MCPB Item No. 4B Date: 06-18-15

Frederick Road Bike Path, Mandatory Referral, MR2015025: Preliminary/Final Water Quality Plan

*B. Frederick Road Bike Path: MR 2015025 Preliminary/Final Water Quality Plan

Figure 2. Shared Use Path in area of proposed stream crossing

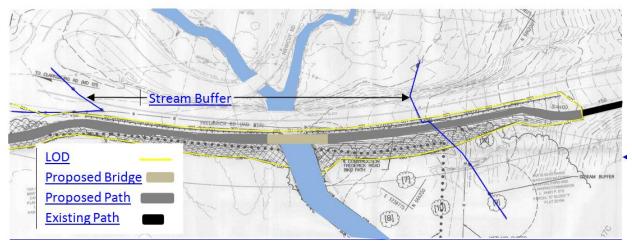
The shared use path will impact Little Seneca Creek and its associated environmental buffer as shown on Sheet 10 of the approved Forest Conservation Plan Exemption and Tree Save Plan 42015156E (Figure 2). The path is narrowed down to eight-feet wide at the bridged stream crossing to decrease impacts to the stream and forest loss. There will be approximately 15,285 square feet of disturbance within the environmental buffer which results in 7,975 square feet of forest loss. The impact to the stream and environmental buffer are necessary and unavoidable if this master plan path connection is to be achieved. The impacts have been minimized to the greatest extent possible while maintaining the accepted MDSHA design standards for constructing this regional shared use path.
